THE CEDARS SUBDIVISION

APPLICATION NUMBER 9 DATE May 7, 2015

DETAIL SITE PLAN

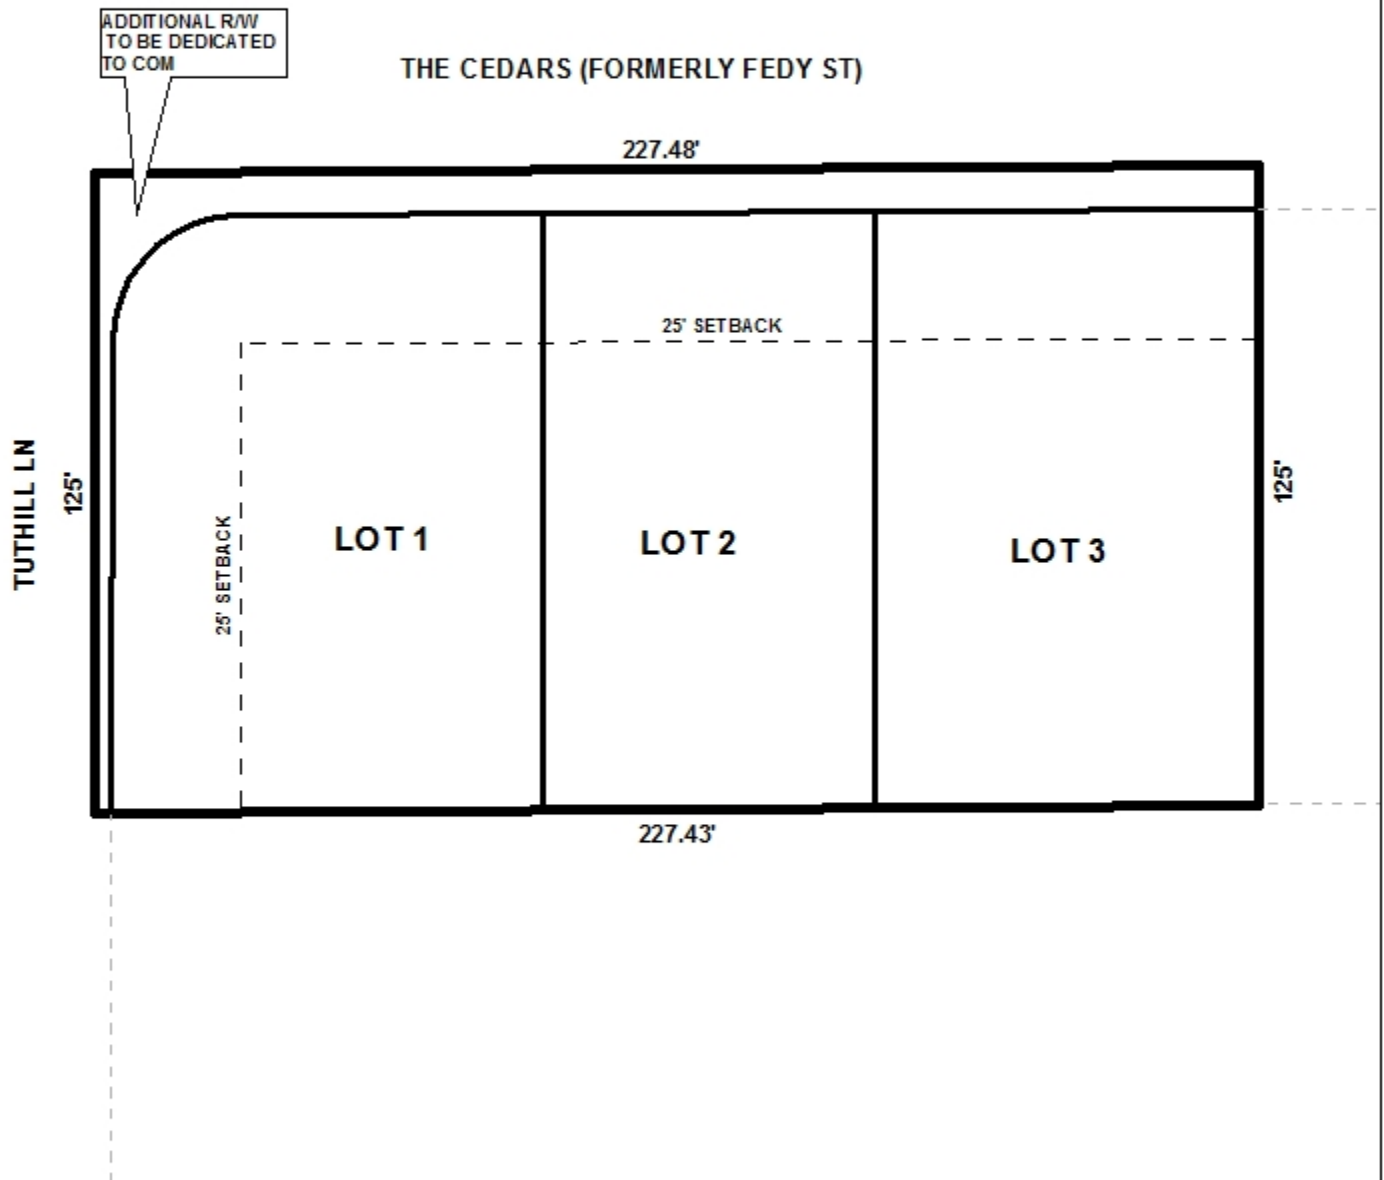
- D. Show and label the POB.
- E. If the ROW is proposed to be dedicated with the recording of this Plat label as “HEREBY DEDICATED”
- F. Provide and label the monument set or found at each subdivision corner.

The site is located at the corner of Tuthill Lane and The Cedars, both minor streets with curb and gutter. The plat as illustrated, has sufficient dedication providing 50' from the centerline of both Tuthill Lane and The Cedars. The plat also depicts dedication of a corner radius at this intersection in compliance with Section V.D.6. of the Subdivision Regulations.

The minimum building setback lines are illustrated on the plat. The plat depicts Lot 1 as having a 25-foot minimum building setback along both Tuthill Lane and The Cedars. Lots 2 and 3 depict a 25-foot minimum building setback along The Cedars only. The 25-foot minimum building setback for each lot should be retained on the Final Plat, if approved.

As a means of access management, a note should be required on the Final Plat, if approved, stating that Lots 1, 2, and 3 are limited to the one curb cut each, with the size, location and design to be approved by Mobile County Engineering and conform to AASHTO standards.

The proposed lot sizes are provided in square feet and acres, and would exceed the minimum required lot size in Section V.D.2. of the Subdivision Regulations. This information should be retained on the Final Plat, if approved.

- 1) Dedication sufficient to provide 50' from the centerline of both Tuthill Lane and The Cedars, as shown on the preliminary plat;
- 2) Dedication of the corner radius at the intersection of Tuthill Lane and The Cedars in compliance with Section V.D.6. of the Subdivision Regulations, as shown on the preliminary plat;

- 3) Retention of the 25' minimum building setback along both Tuthill Lane and The Cedars for Lot 1;
- 4) Retention of the 25' minimum building setback along The Cedars for Lots 2 and 3;

- 5) Placement of a note on the Final Plat, stating that Lots 1, 2, and 3 are limited to one curb cut each, with the size, location and design to be approved by Mobile County Engineering and conform to AASHTO standards;

- 6) Retention of the lot size for each lot in square feet and acres on the Final Plat, if approved; and
- 7) compliance with Fire Department comments (*All projects within the City of Mobile Fire Jurisdiction must comply with the requirements of the 2009 International Fire Code, as adopted by the City of Mobile. As per Appendix D, Section D107.1, one and two family developments with more than 30 dwelling units shall be provided with separate and approved fire apparatus access roads and shall meet the requirements of Section D104.3.*).
